THE MARYLAND-NATIONAL CAPITAL PARK AND PLANNING COMMISSION

## MEMORANDUM

**REVIEW TYPE:** Final Water Quality Plan and Site Plan Review  
**APPLYING FOR:** Approval of 487 dwelling units (153 SFD, 202 TH's and 132 multifamily units) inclusive of 46 MPDU's on 77.61 acres  
**PROJECT NAME:** Clarksburg Town Center Phase II  
**CASE #:** 8-02014  
**REVIEW BASIS:** Sec. 59-D-3, M. C. Zoning Ordinance

# CLARKSBURG TOWN CENTER (8-02014)

OVERALL SITE PLAN  
PHASE II

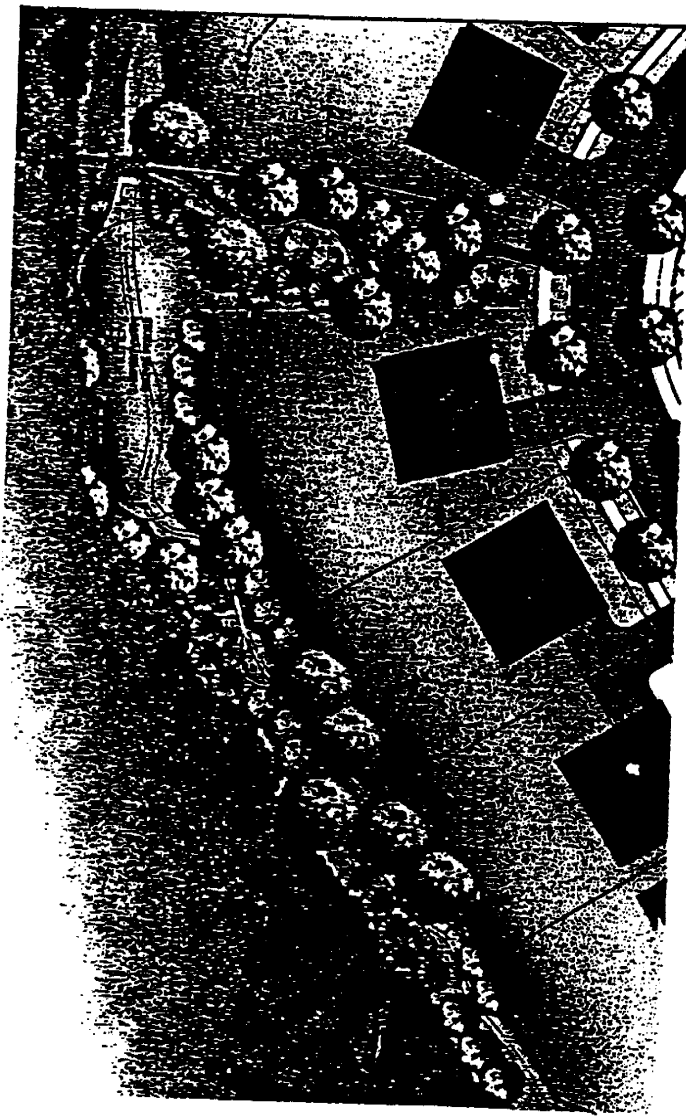
- f. Applicant to construct paved hiker/biker trails in the following locations:

1. Along the east side of Overlook Park Drive from Stringtown Road to Clarksburg Road (Route 121). Per Phase I approval. This trail will be aligned to meet the Clarksburg Greenway Trail from the south side of Stringtown Road.

2. From the Clarksburg Greenway Trail along Overlook Park Drive to the Kings Local Park pond trails (two connections to the pond trail) - per Phase I approvals

3. Along the south side of Clarksburg Road from the pond area trails to the intersection with Piedmont - per Phase I approvals
4. Along the south side of Piedmont from Clarksburg Road to Street "F" - per phase one approvals

5. Along the west side of Street "F" from Piedmont to Main Street and continuing along Main Street to the Greenway Trail along Overlook Park Drive - within the right-of way per DPWT standards.

6. Trails are to be constructed to park standards when outside of right-of-way. Exact trail alignments to be coordinated with M-NCPPC and DPWT staff, and should be appropriately located and landscaped to maintain a park like setting while also fulfilling the need for safe, off road transportation in the area.

# Park School Site

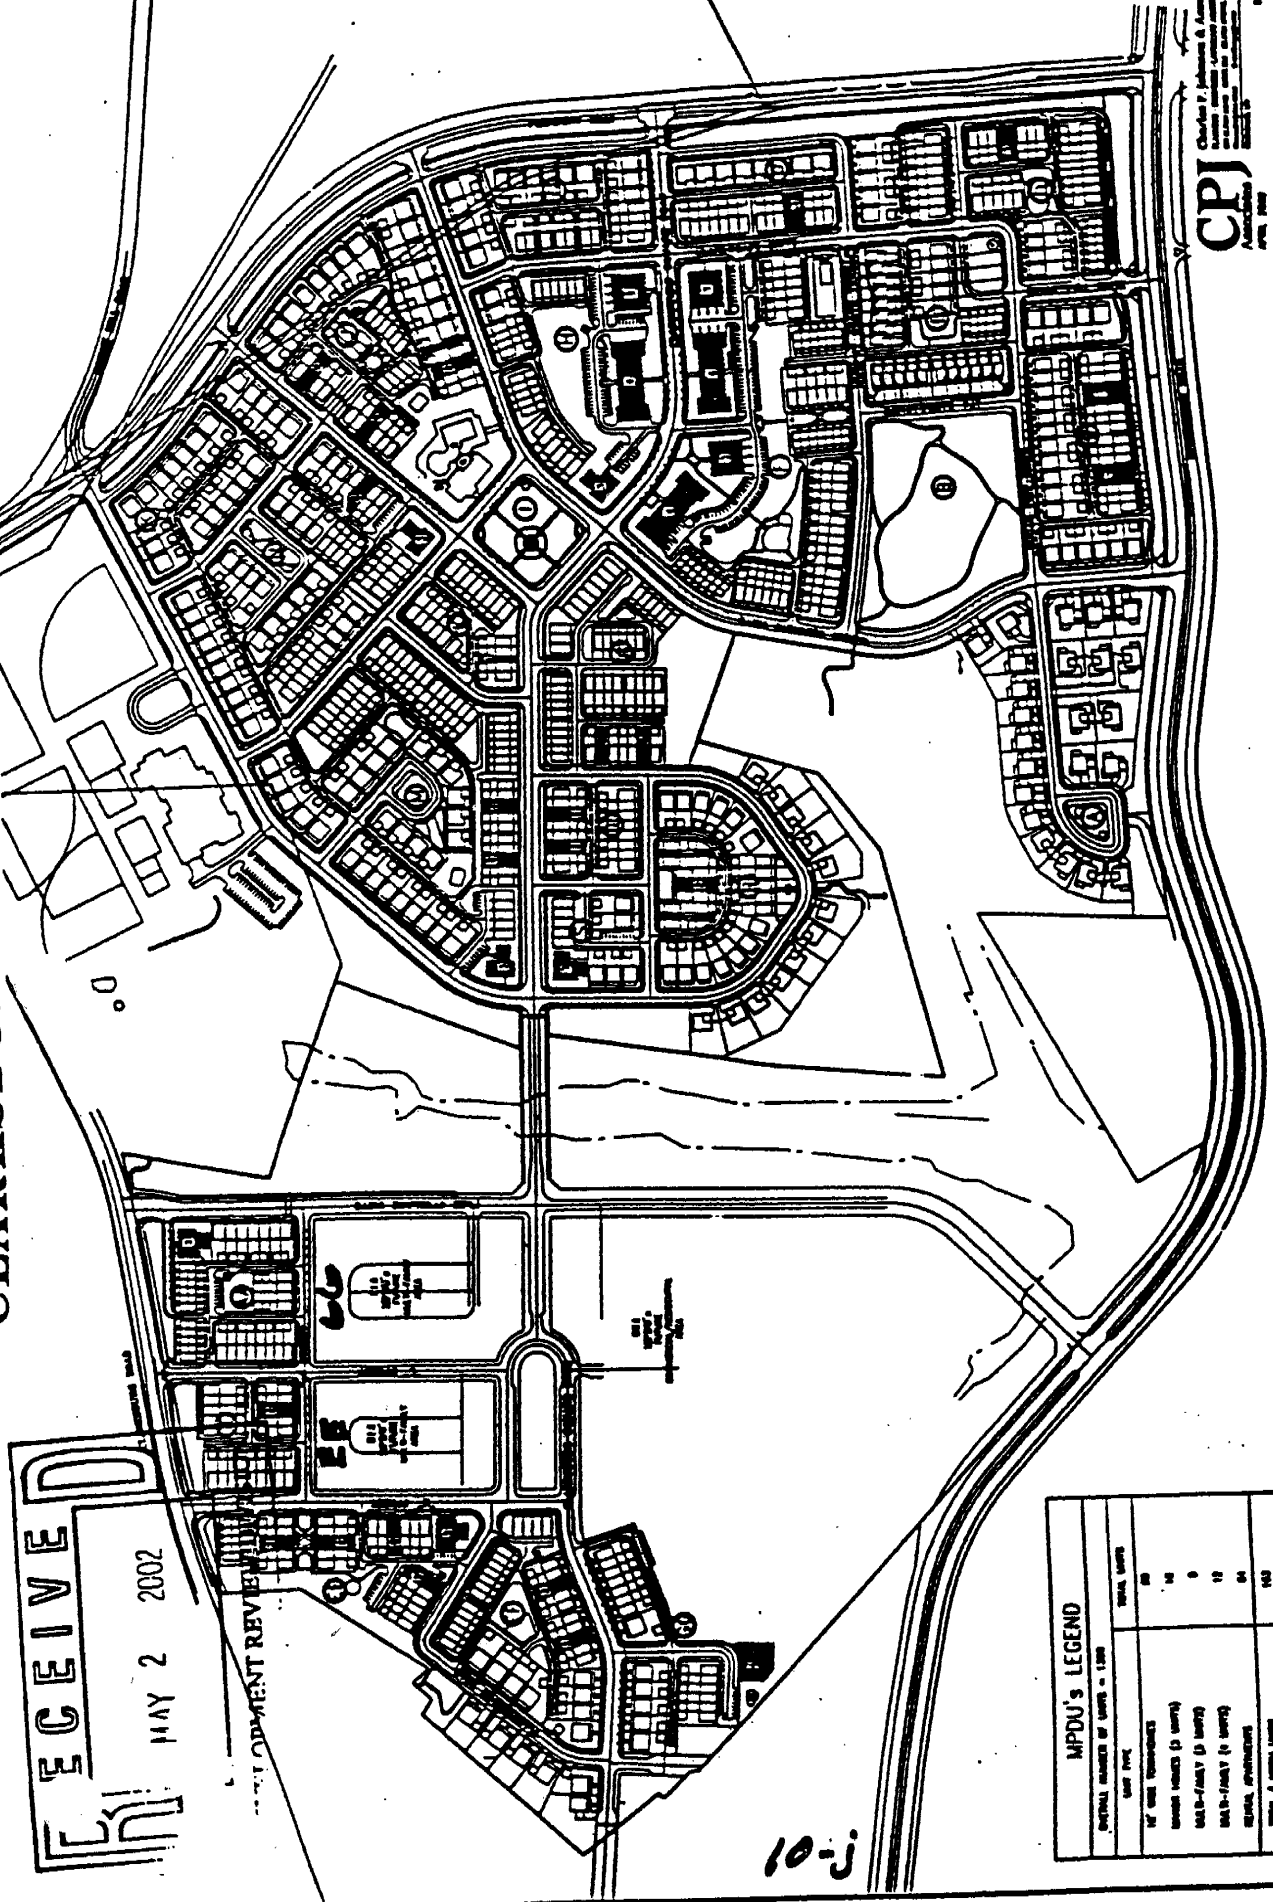
3. Park and School Site
  - a. Per MCPS Memo of May 2, 2002, the applicant shall provide adequate engineered fill for the building and rough grade the remainder of the school site to allow school construction at a reasonable cost. Alternatively, if this cannot be done, MCPS will consider another site within the subdivision pending revision of the applicable Preliminary and Project Plans. (Memo attached)

- c. ~~2~~ Applicant shall acknowledges that there is sufficient earth material on site to construct both fields and agrees to construct the two fields upon commencement of construction of Street "F" referenced in the Preliminary Plan approval, or prior to construction of the proposed elementary school, whichever occurs first.

- i. The exact location and orientation of the fields to be coordinated with M-NCPPC staff.
  - ii. The softball field to be full sized with foul lines of 290'.

- iii. The soccer field to be full adult size with dimensions of 360' by 220'.
- d. Final details regarding the Park/School site shall be reviewed by staff and shall reflect the direction of the approved Preliminary Plan # 1-95042 and shall include input from the Parks Department, MCPS and the Applicant for the final design of the ball field and path layout, the metes and bounds survey of dedication prior to recordation, grading, access, storm water management facilities and any other issues as required.

In the course of site plan review, as the park/school plan was being developed, issues of concern have developed. A letter from MCPS is attached which recites their concerns with the current school site location due to the severe grading problems associated with the site. They are asking the Planning Board to require the applicant to provide engineered fill to compensate for the considerable elevation changes – 20 feet in some areas of the site.

With the Planning Board's concurrence, the final grading plan will be finalized after the Site Plan approval in order to work out grading and other details of the submittal listed in the conditions above.
